ADDENDUM No. 2

Re: UNC Charlotte – Residence Hall Phase XVI
SCO ID: 18-18333-02E
JPA Project #: 18NCC016

The following items are intended to revise and clarify the Drawings and the Project Manual.

C-200

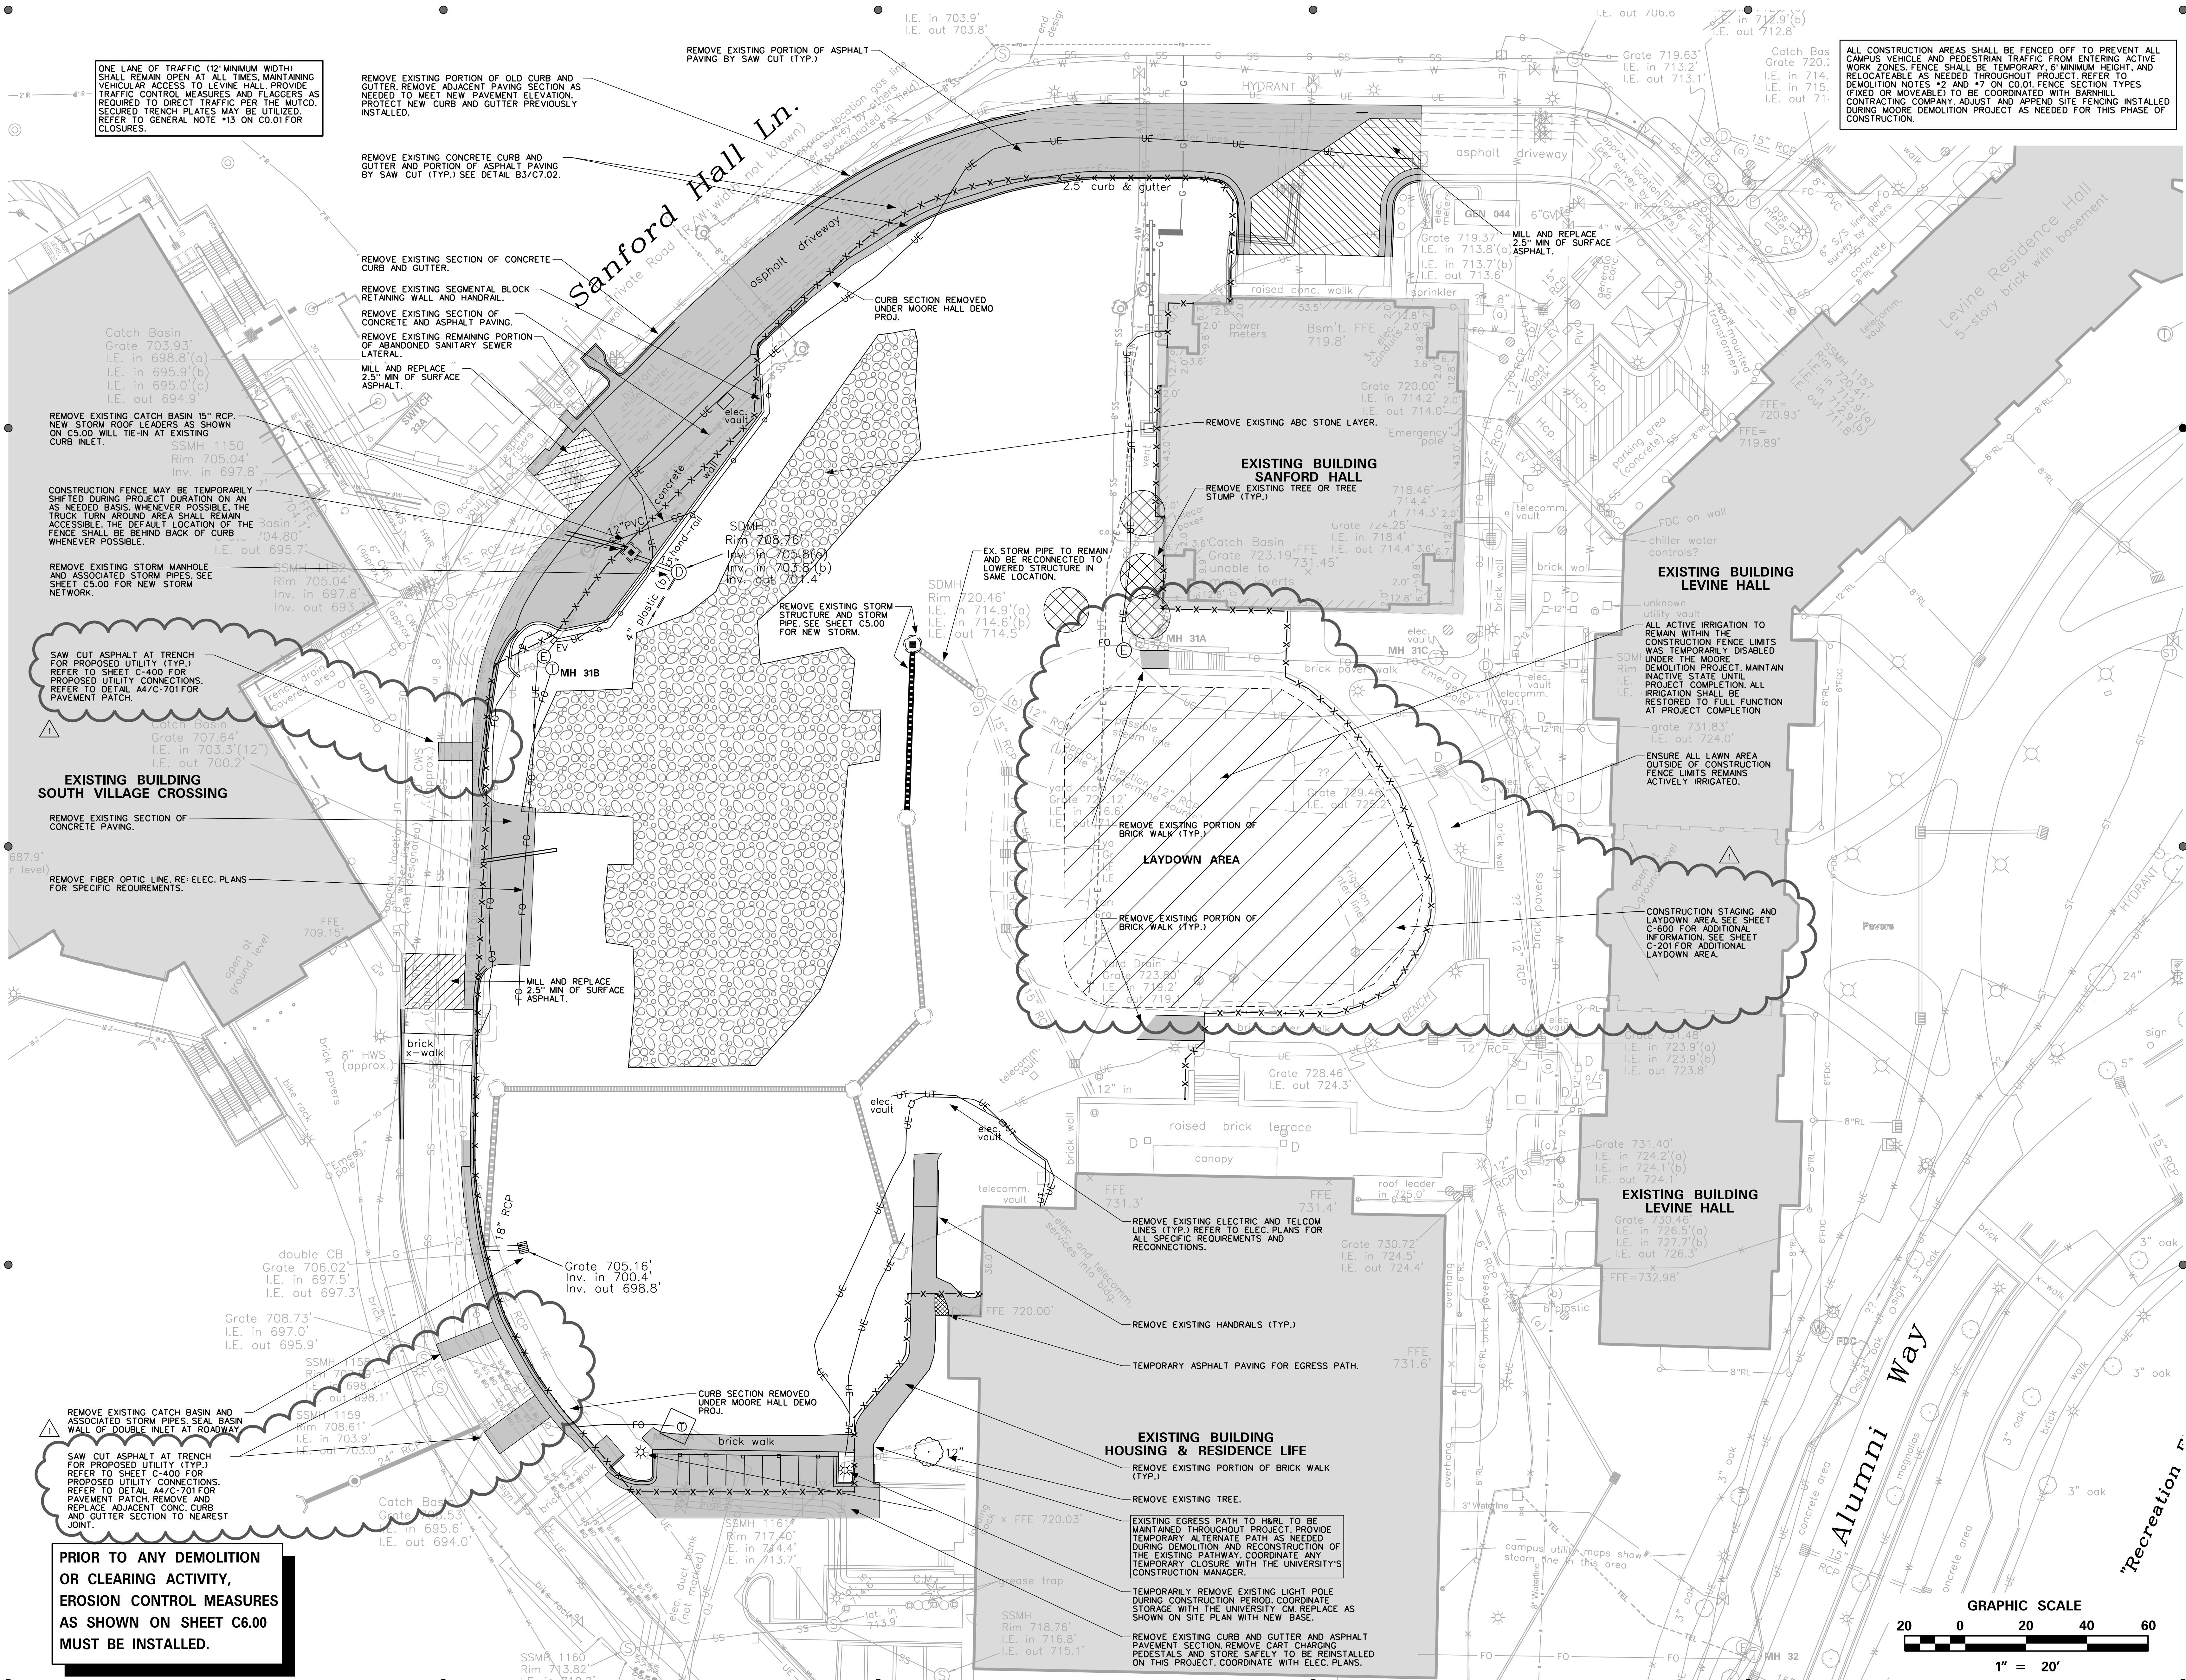
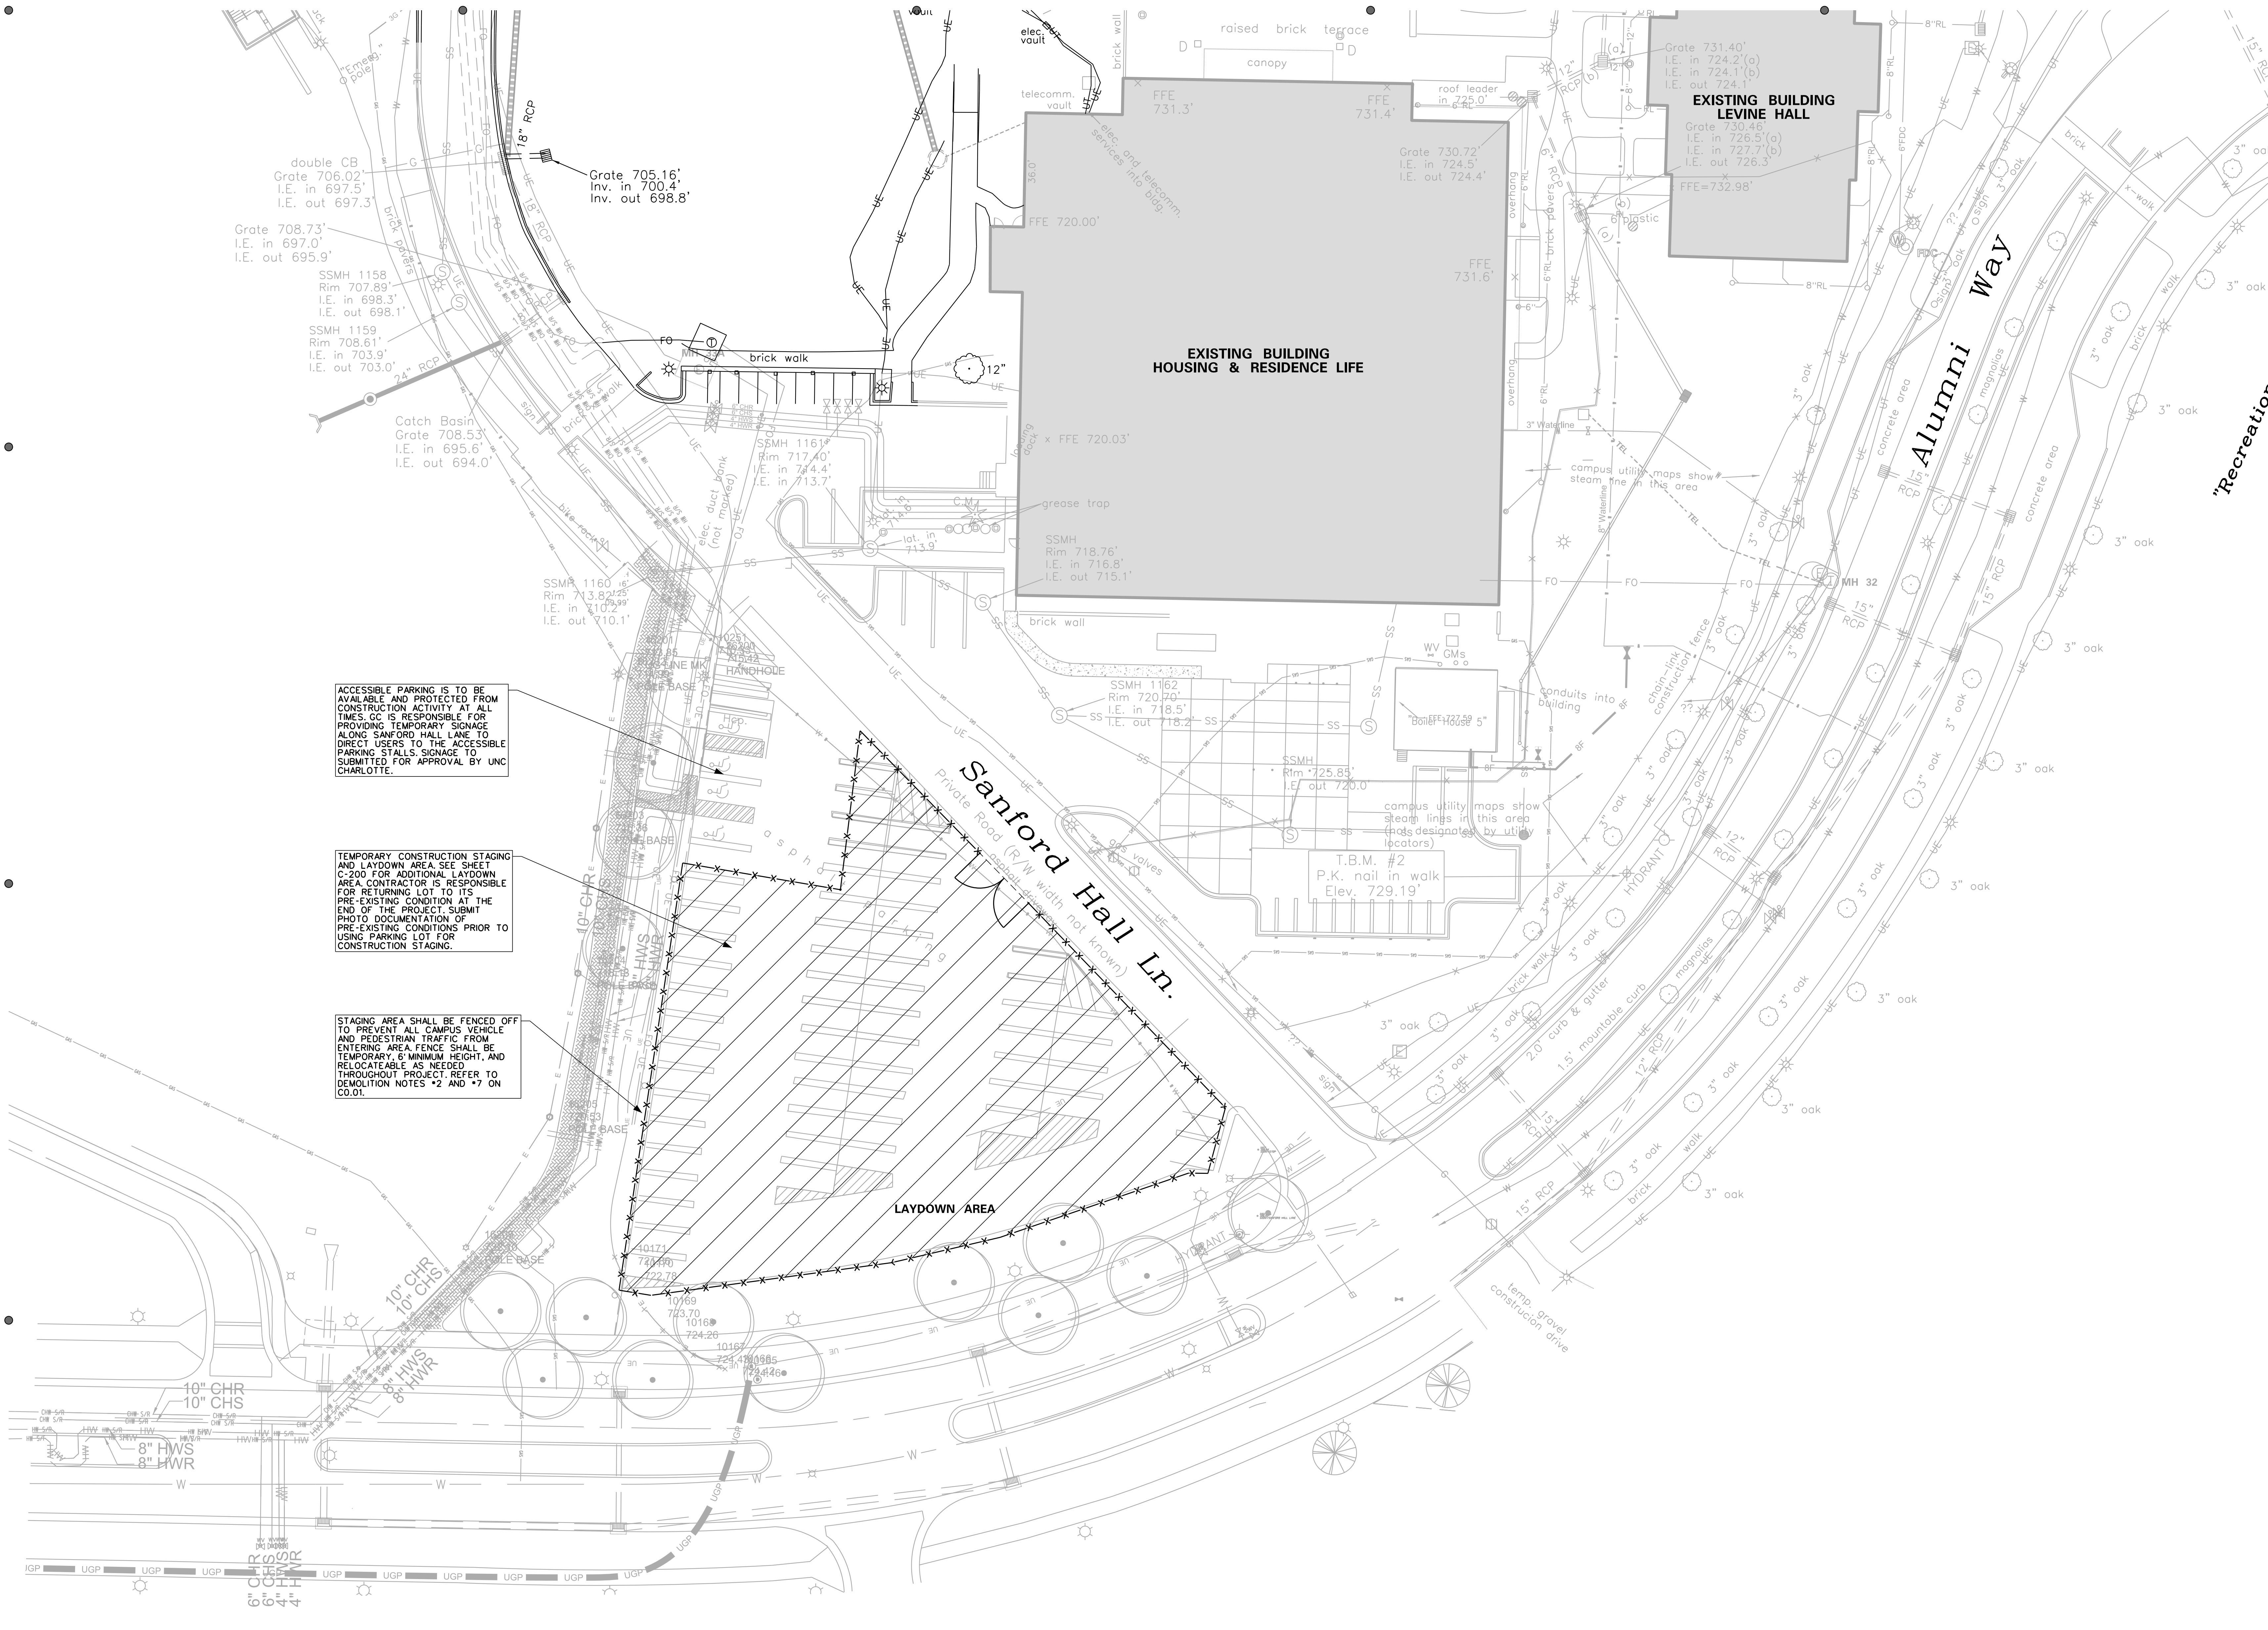
9. On Sheet C-400 new utility lines (water and sewer) are shown crossing Sanford Hall Lane. Please indicate demolition and patching for these lines on C-200 and C-300.

10. In the Storm Drainage Schedule on C-500, some of the pipe scheduled is located between two existing structures but is shown on the schedule as new pipe (not labeled as “EX”) -i.e. piping between structures EXCB 10, EXCB 12, EXMH 15 and EXCB13A, EXMH 15, EXMH 17. This piping also is shown on C-200 as existing. Please clarify this piping is existing on the schedule.

RESPONSE: See revised civil sheets included in this Addendum.

RESPONSE: See revised civil sheets included in this Addendum
